UNITED STATES
DEPARTMENT OF THE INTERIOR
BUREAU OF LAND MANAGEMENT**SUNDRY NOTICES AND REPORTS ON WELLS**
*Do not use this form for proposals to drill or to re-enter an abandoned well. Use form 3160-3 (APD) for such proposals.*FORM APPROVED
OMB NO. 1004-0137
Expires: January 31, 20185. Lease Serial No.
NMNM115421

1. Type of Well <input checked="" type="checkbox"/> Oil Well <input type="checkbox"/> Gas Well <input type="checkbox"/> Other		Carlsbad Field Office OCD Hobbs	8. Well Name and No. JENNINGS 27 B2AP FED COM 2H
2. Name of Operator MEWBOURNE OIL COMPANY			9. API Well No. 30-025-43342-00-X1
3a. Address P O BOX 5270 HOBBS, NM 88241		3b. Phone No. (include area code) Ph: 575-393-5905	10. Field and Pool or Exploratory Area WC025G08S253235G-LWR BONE SPI
4. Location of Well (Footage, Sec., T., R. M., or Survey Description) Sec 27 T25S R32E NENE 185FNL 660FEL			11. County or Parish, State LEA COUNTY, NM

Mewbourne Oil Company has an approved APD for the above well. Mewbourne requests approval to make the following changes:

DRILLING CONDITIONS OF APPROVAL

WELL LOCATION AND ACREAGE DEDICATION PLAT

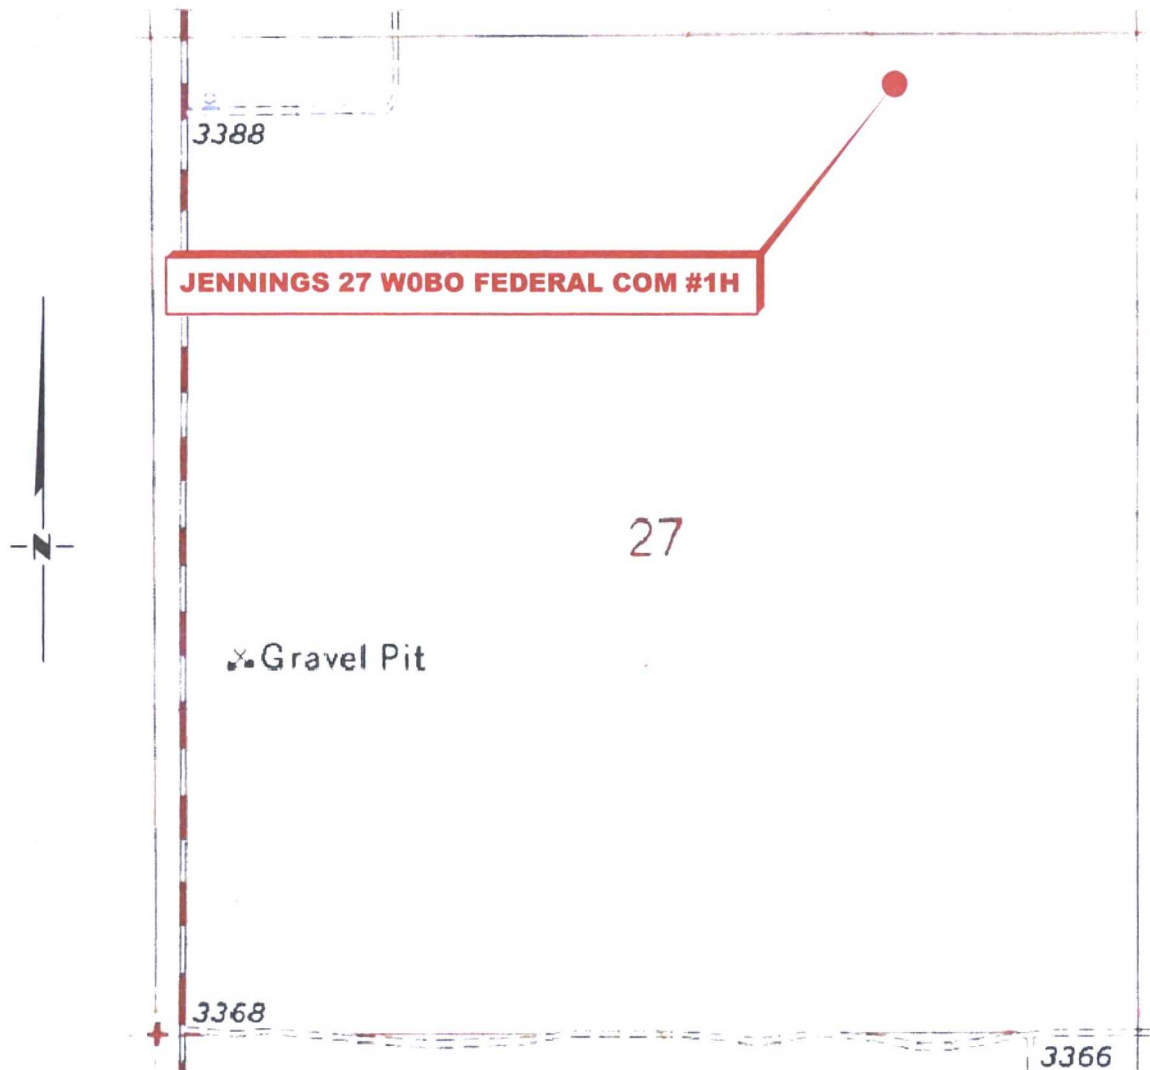
- (321382)
- 1) Change well name to Jennings 27 W0BO Fed Com #1H. *PCN 3/23/18*
 - 2) Change pool to 98203.
 - 3) Change target zone to Wolfcamp & TVD to 12,063'.
 - 4) Change SL to 275' FNL & 1310' FEL. *PCN 3/23/18*
 - 5) Change BHL to 330' FSL & 1650' FEL.
 - 6) Change csg depth and cement to suit new plan.
 - 7) Change wellhead to multi-bowl type wellhead.

Jennings 27 W0BO Fed Com #1H

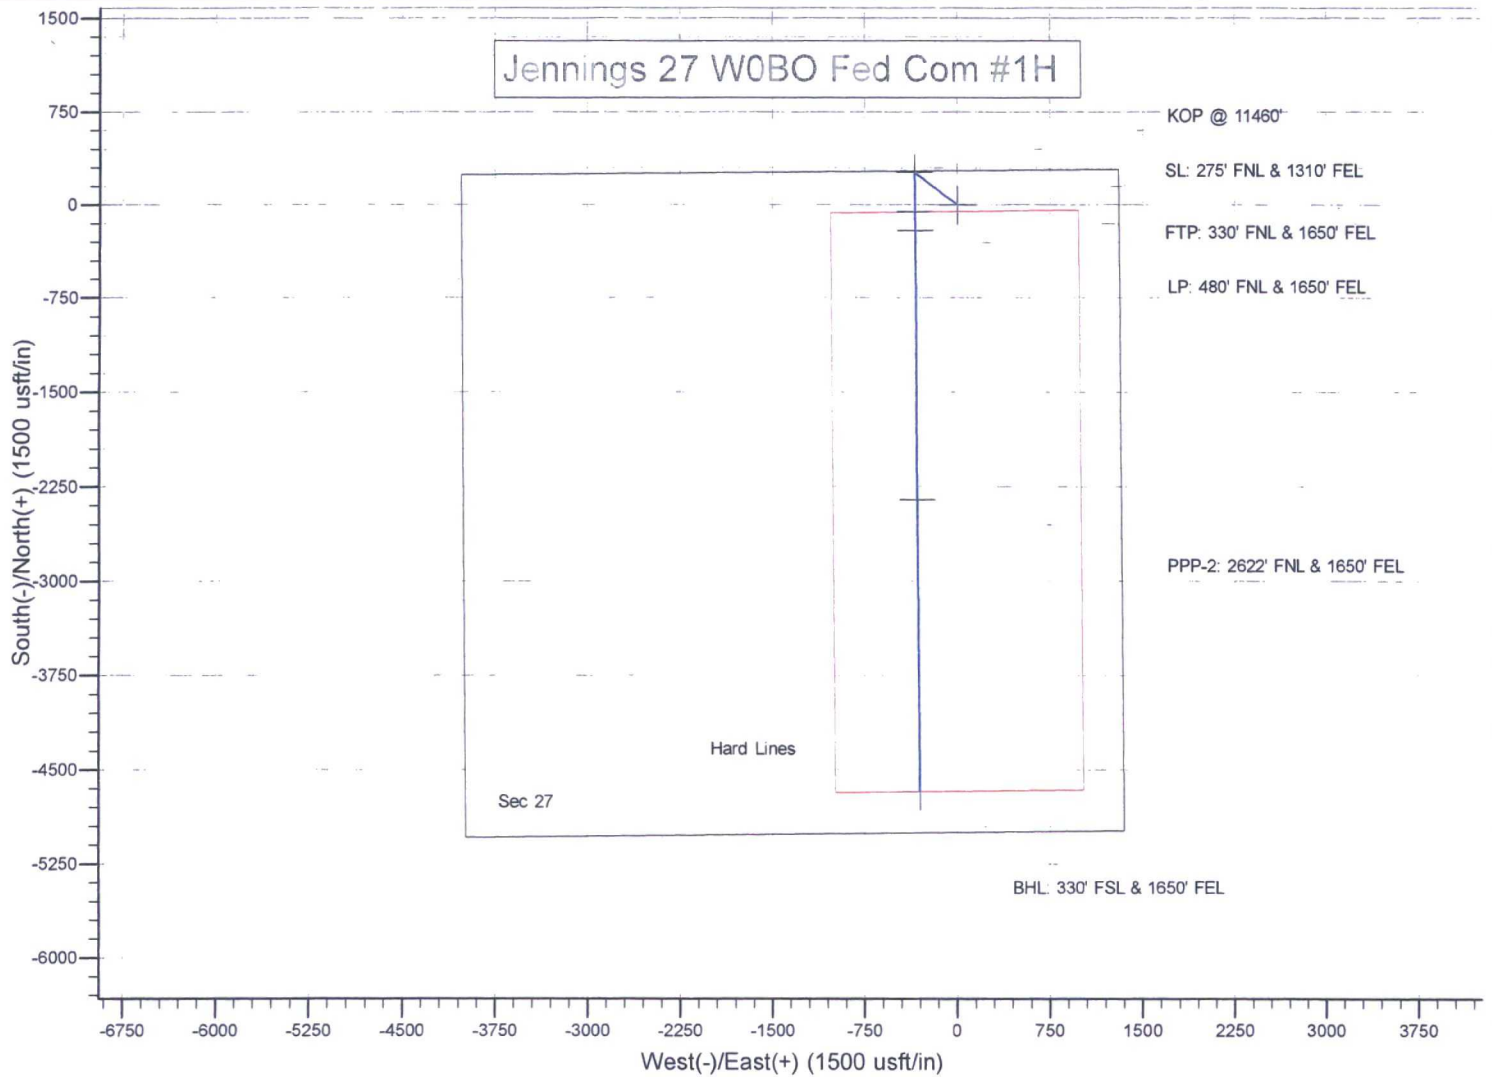
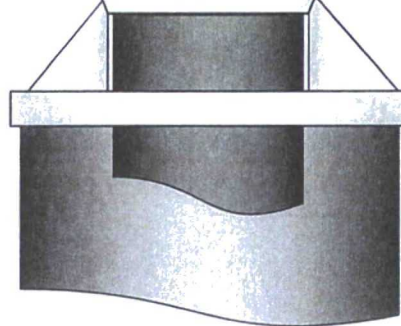
10,000 PSI Annular BOP Variance Request

Mewbourne Oil Company request a variance to use a 5000 psi annular BOP with a 10,000 psi BOP stack. The component and compatibility tables along with the general well control plans demonstrate how the 5000 psi annular BOP will be protected from pressures that exceed its rated working pressure (RWP). The pressure at which the control of the wellbore is transferred from the annular preventer to another available preventer will not exceed 3500 psi (70% of the RWP of the 5000 psi annular BOP).
